Index 711-001 Pavement Markings

COMMENTARY

COMMENTS AND RESPONSES

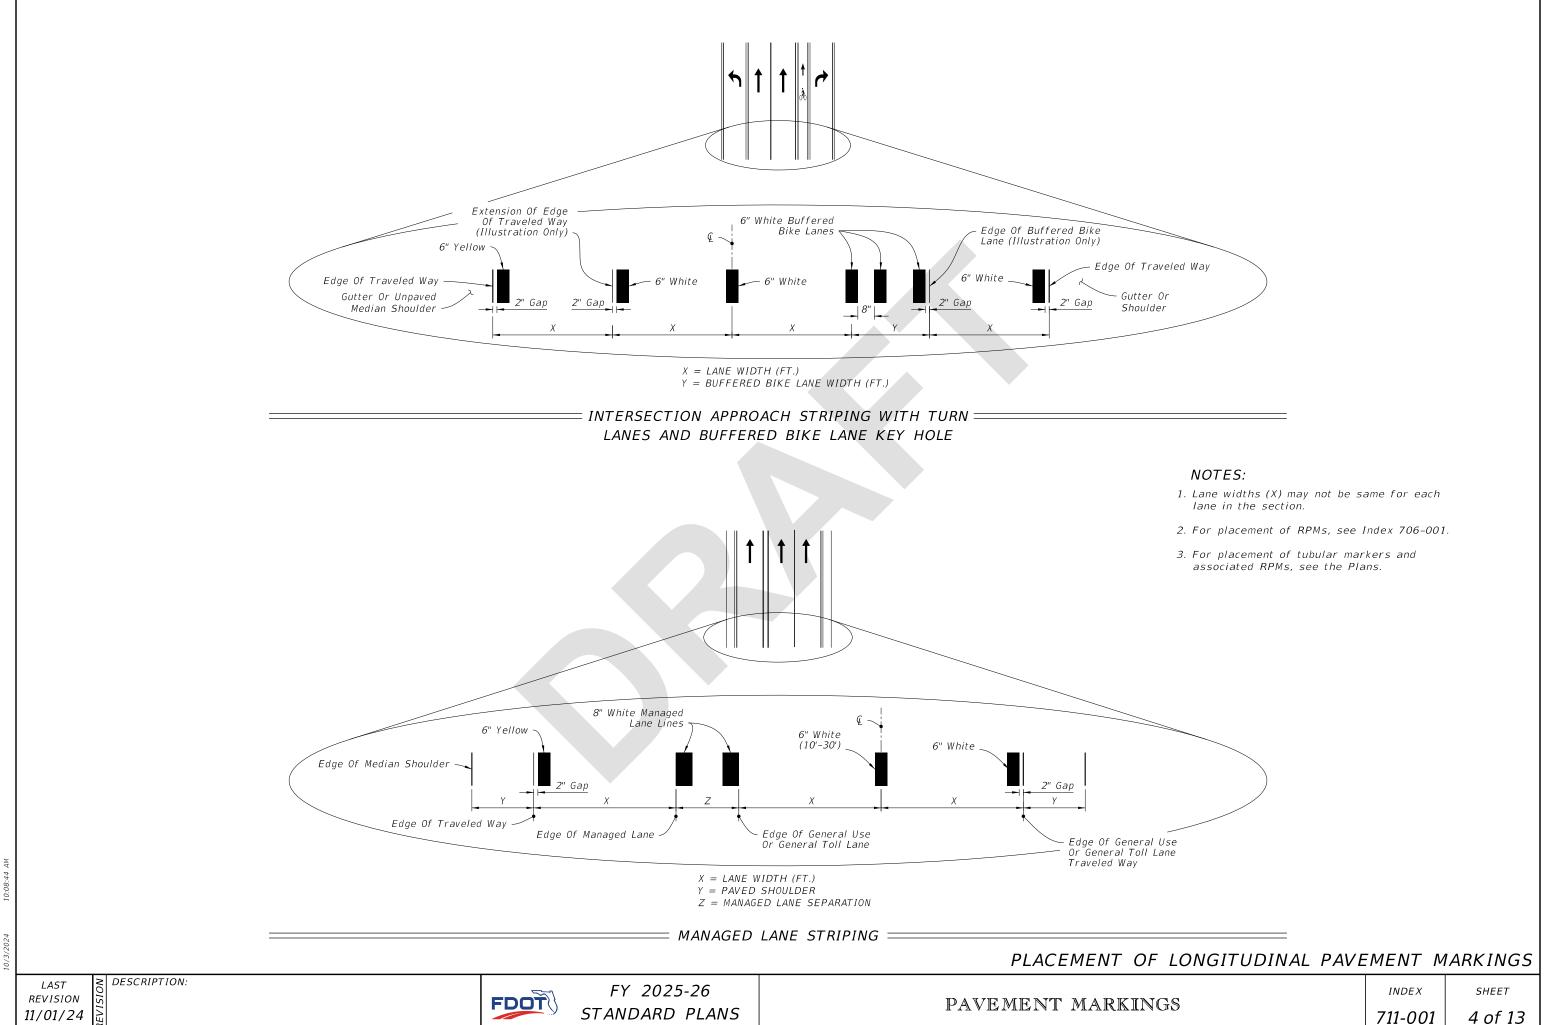
COMMENT: For the managed lane pavement marking diagram at the bottom of 711-001 sheet 4 to be consistent with the other longitudinal marking diagrams, the edge of travel lines for the outside lanes should be shown in the plan view (they currently are not). Additionally, for the same diagram, removing the edge of travel lane lines in the plan view for the two 8" managed lane markings may be more clear, as there is no offset gap from the lane lines to the markings. Thank you for the opportunity to provide feedback.

RESPONSE: Thank you for the comment. The goal was to match the zoomed-out detail to the zoomed-in detail. We will look at these in more detail and update as necessary.

CHANGE MADE TO INDEX: Yes. Added double lines to Managed Lane detail.
